COMMUNITY DEVELOPMENT DEPARTMENT REPORT

HEARING 9/17/2026
DATE: *Continued from 7/2/2026 and 8/20/2026*

APPLICANT: Derek Rindlisbacher, Bach Homes

SUBJECT: Regency at River Valley Phase 3 –
CUP, MDA
H-2026-0010

E. Proposed Site Plan (date: ~~4/9/2026~~ 9/3/2026) – REVISED

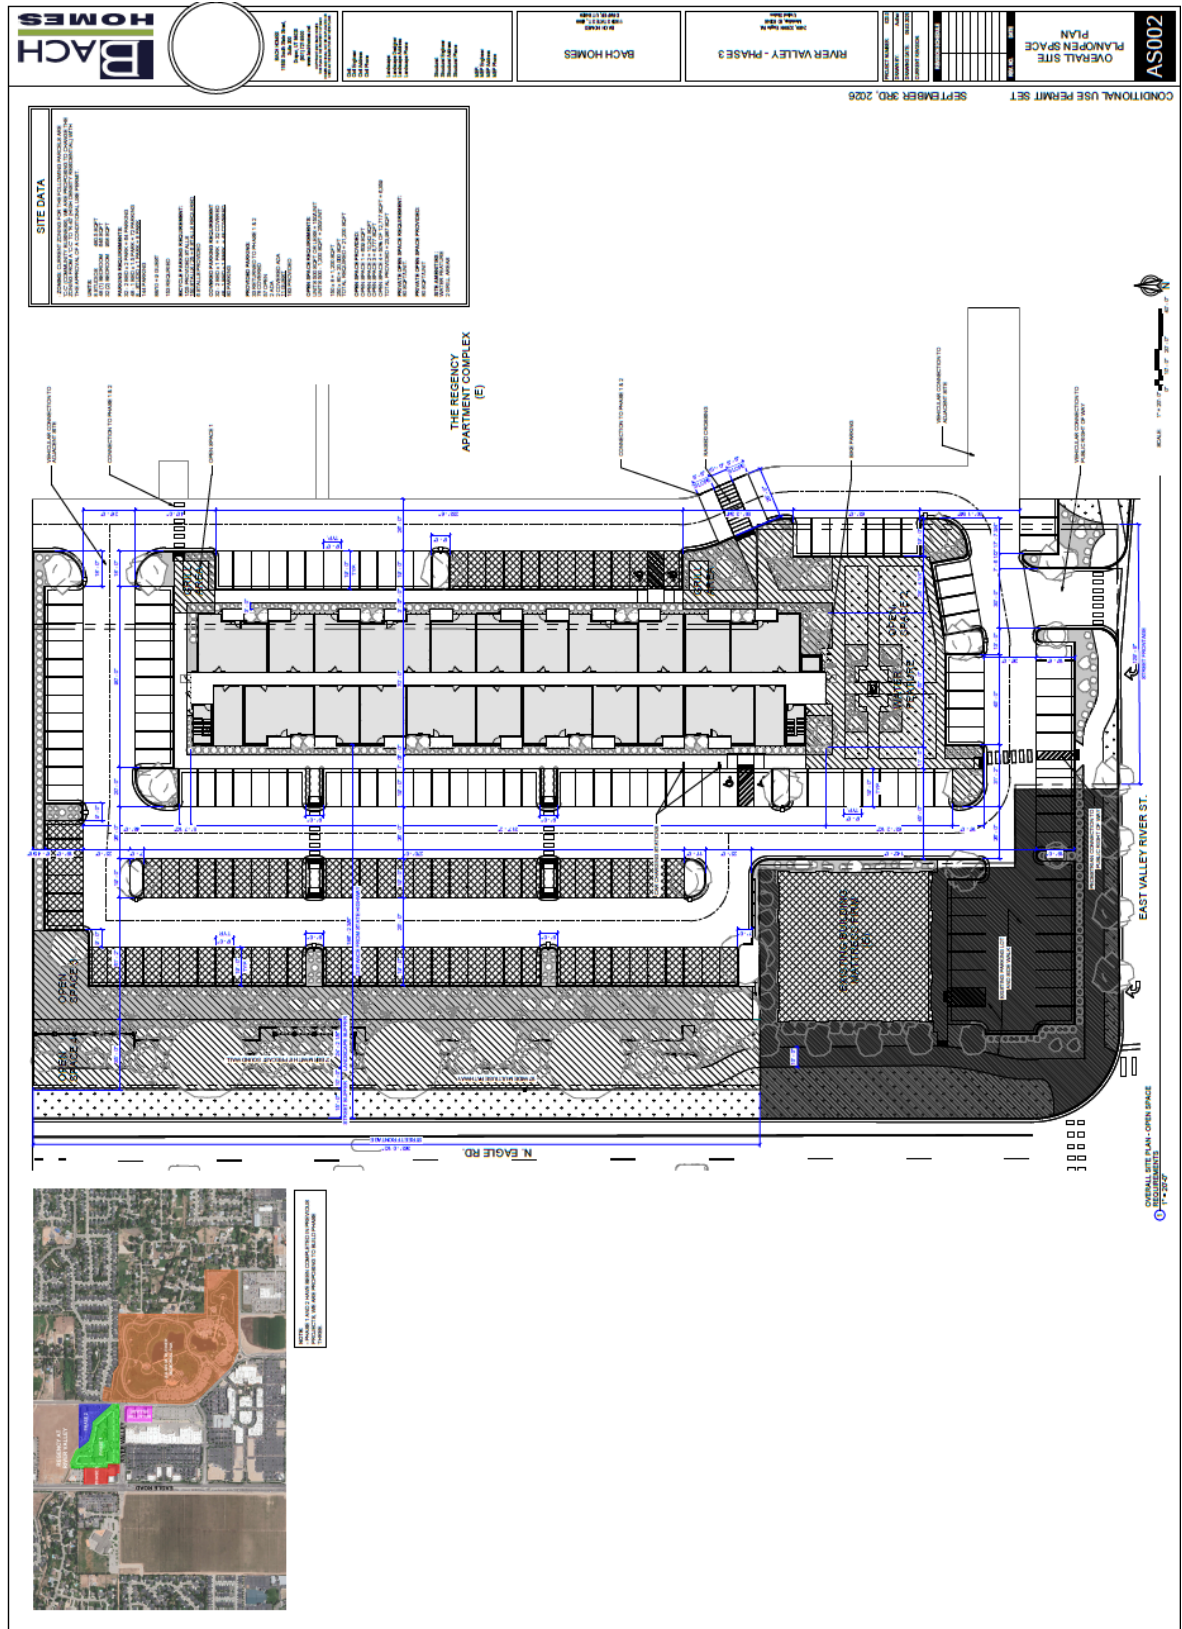
2. All on-site service areas, outdoor storage areas, waste storage, disposal facilities, and transformer and utility vaults shall be located in an area not visible from a public street, or shall be fully screened from view from a public street. *A trash enclosure is depicted on the site plan at the south end of the development at the entry to the site, which is visible from River Valley St. **A detail of the trash enclosure should be submitted with the Certificate of Zoning Compliance that depicts doors that screen the enclosure from the public street.***

*These items are not depicted on the site plan. The Applicant states the property management office, maintenance storage area and mailboxes will be in the clubhouse in the existing apartment complex and the existing directory & map will be updated with Phase 3 information. **Staff recommends a directory & map be provided at the entry to Phase 3 from River Valley St. if approved.***

*The property to the north was required to grant emergency vehicle access to this property if developed with a residential use (H-2022-0009 Copper Canary – DA Inst. #2022-048293). **The site plan does not depict an access drive from the north; however, the Fire Dept. will has determined if this access isn’t still necessary with access available through the adjacent development to the east via Records Ave. and the Sessions Parkway development to the north.***

G. Proposed Building Elevations & Perspectives (date: 4/9/2026 9/3/2026) – REVISED

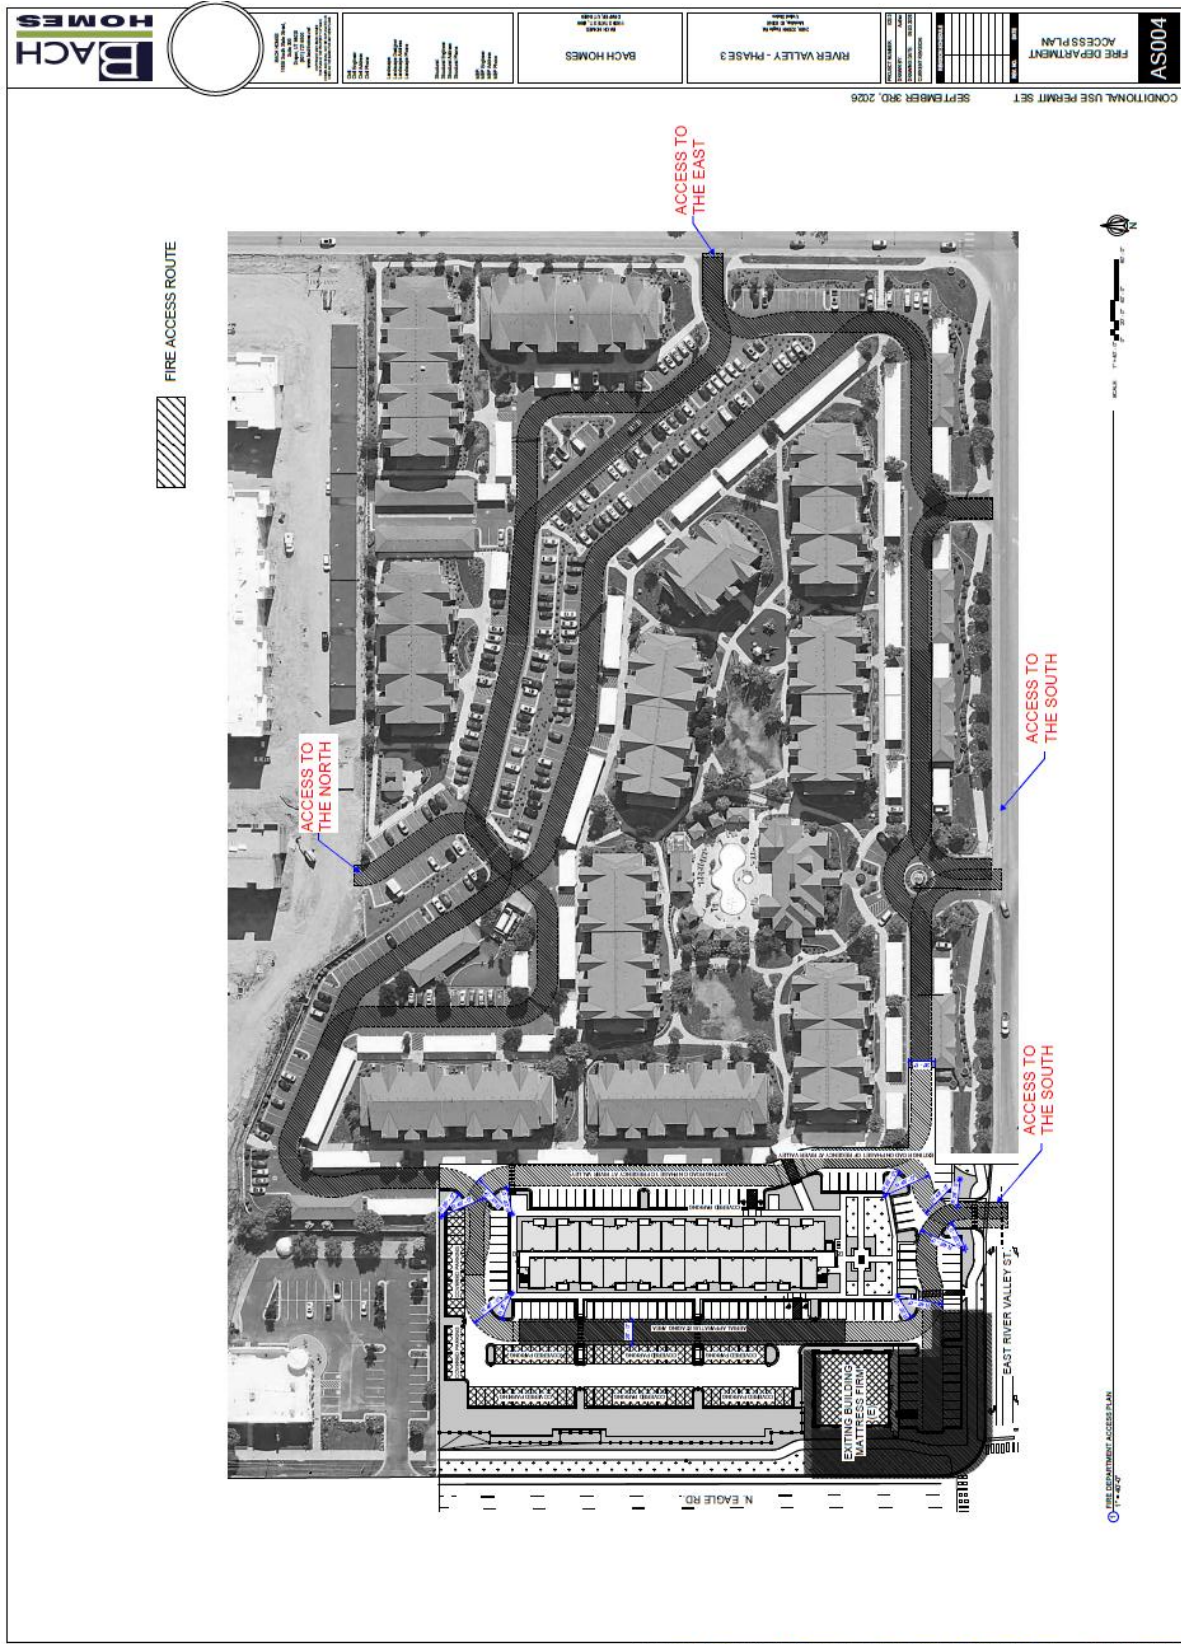
The form of the proposed structures at 4-stories in height doesn't provide an adequate transition to existing single-story (with higher parapet) commercial structures to the north and south along Eagle Rd. A transition in building height should be provided from the commercial structures and the Eagle Road corridor to the 4-story buildings directly to the east.

The design of the proposed buildings isn't compatible with adjacent commercial buildings along the Eagle Road corridor in form or height and doesn't provide a transition to the 4-story multi-family buildings to the east; screening is proposed with a 10' tall berm & wall and landscaping within the street buffer along Eagle Road but will likely not be sufficient to screen 4-story buildings.

The proposed 4-story structures do not integrate well with existing single-story commercial structures to the north and south along Eagle Rd., creating a height disparity between structures along the entryway corridor. Landscaping and a 10' tall berm and wall is proposed within the street buffer; however, with the building height proposed, it provides for little screening.

BACH HOMES		1	CROSS SECTION @ N EAGLE RD RIVER VALLEY - PHASE 3
11650 South State St., Suite 300 Draper, UT 84020 (801) 727-9500 www.bachhomes.net

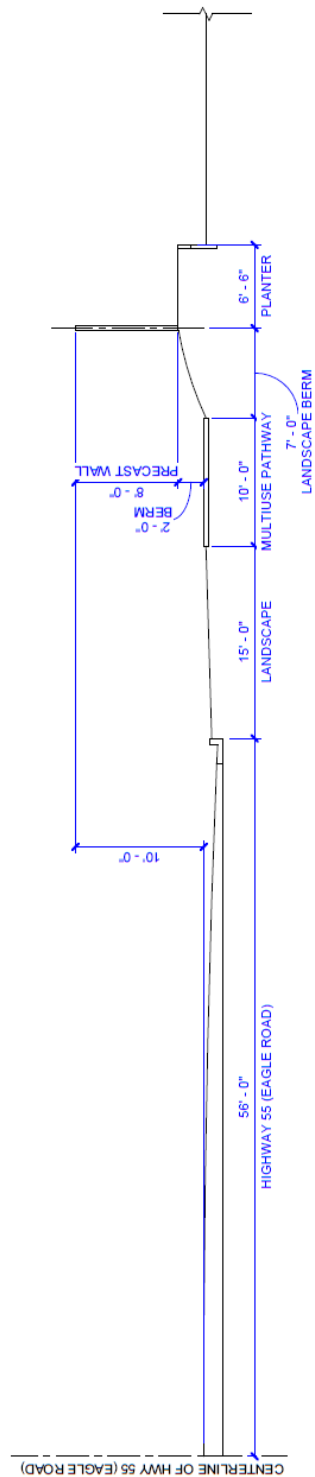
*Noise abatement is required for residential uses along state highways per the standards in UDC 11-3H-4D. An 8’ tall pre-cast sound wall is proposed within the street buffer along N. Eagle Rd./SH-55 on top of a 2’ tall berm. A cross-section of the street buffer depicting the location of the wall is included below in Section VII.G and VII.J that depicts the top of the berm/wall to be 10’ higher than the elevation at the centerline of the state highway as required. **An exhibit should be submitted that demonstrates compliance with all of the required standards along with a detail of the wall that demonstrates it’s a sound attenuating material.***

L. Open Space Exhibit – REVISED (dated: 9/3/2026)

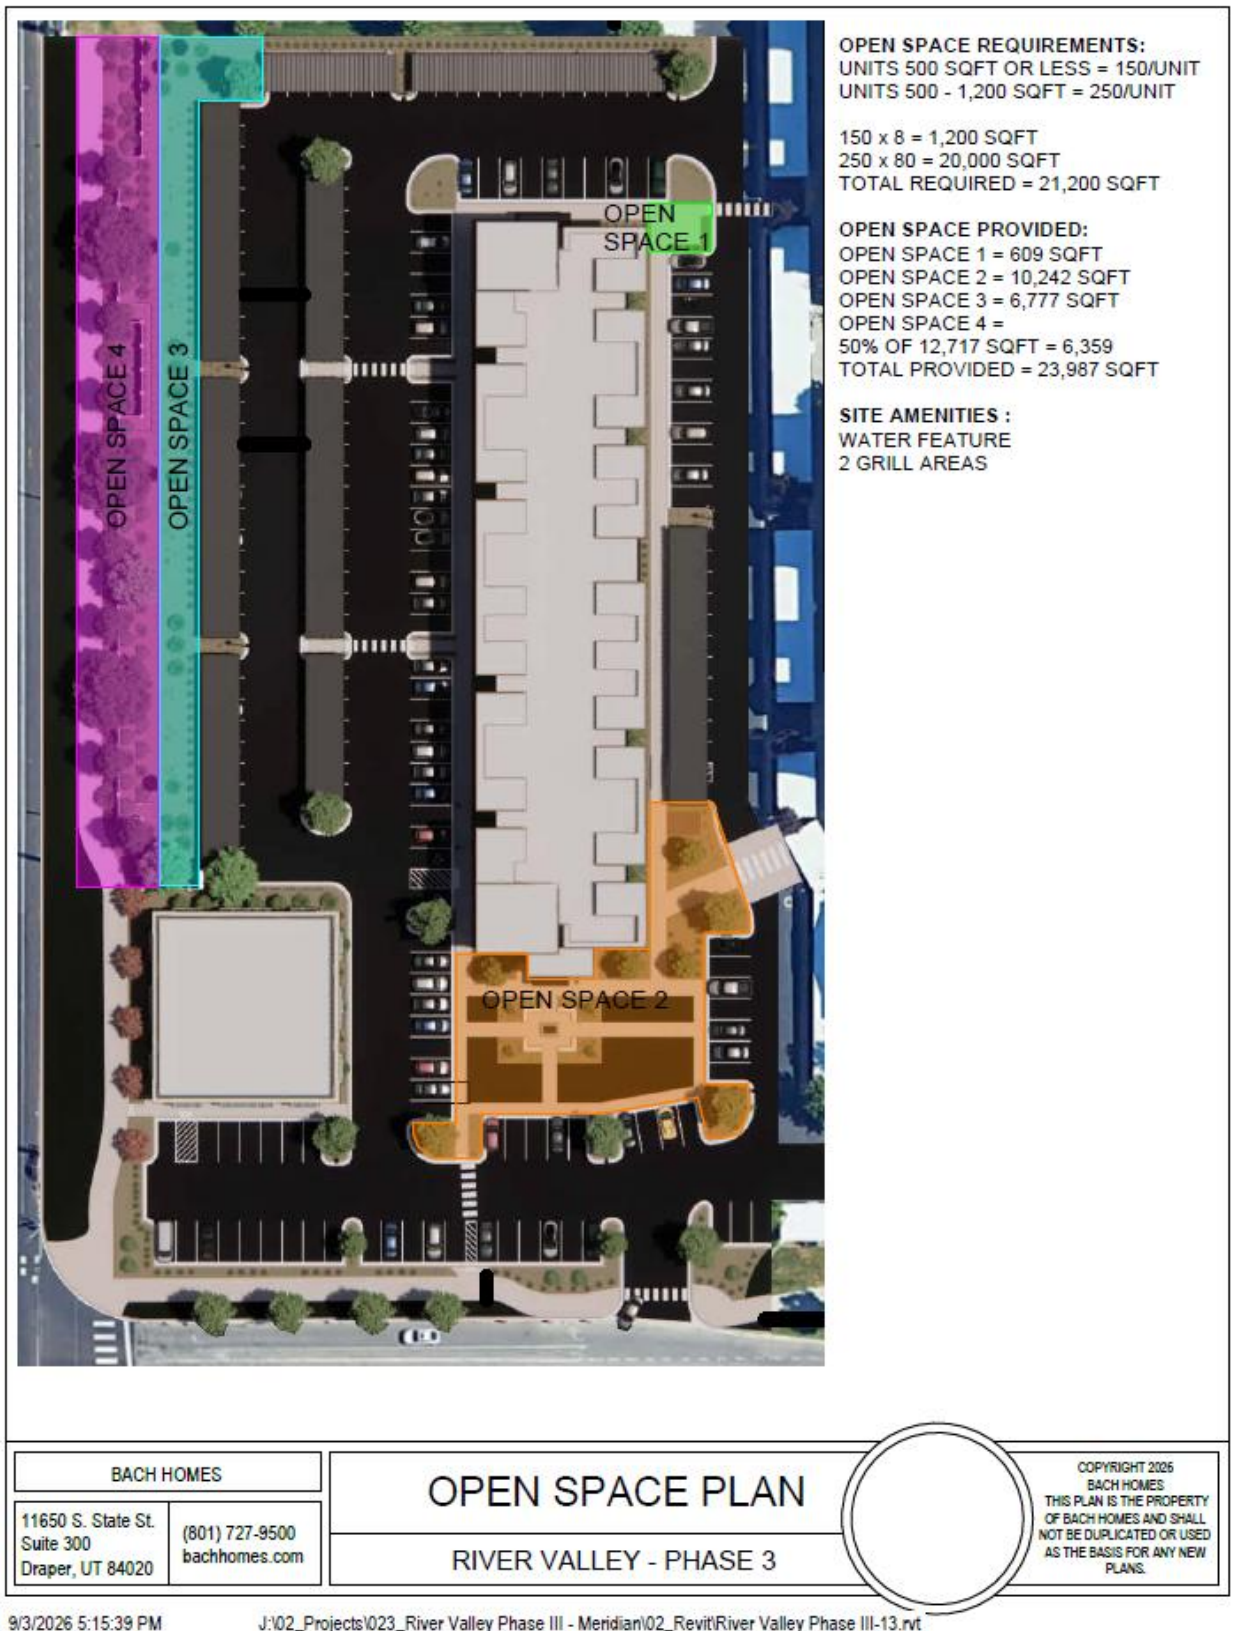
*The area depicted as “Open Space 1 & 2” is ~~the~~ a large open space area on the southern end of this site ~~and that is 7,342~~ 10,242 s.f. in area, including common open space where a ~~walking trail grill area~~ is located ~~leading to the common area~~. **The common area is encumbered by a dog park and water feature with a sitting area so it doesn’t meet the grassy area requirement.** ~~The Applicant should submit an overall open space exhibit for Phases 1, 2 and 3 that demonstrates compliance with this standard for the overall development if the Commission and/or Council directs Staff to prepare conditions of approval.~~*

An open space exhibit was submitted, included below in Section VII.L, that depicts a total of ~~21,751~~ 23,987 s.f. (or 0.55 acre) is provided consisting of half the street buffer along the arterial street (i.e. Eagle Rd./SH-55), linear open space, and a large common open space area. ~~Because the exhibit is not scaleable it’s unclear to Staff if the areas in Open Space 1 and 2 where the walking trails are located are a minimum of 20’ in width to be qualified open space.~~
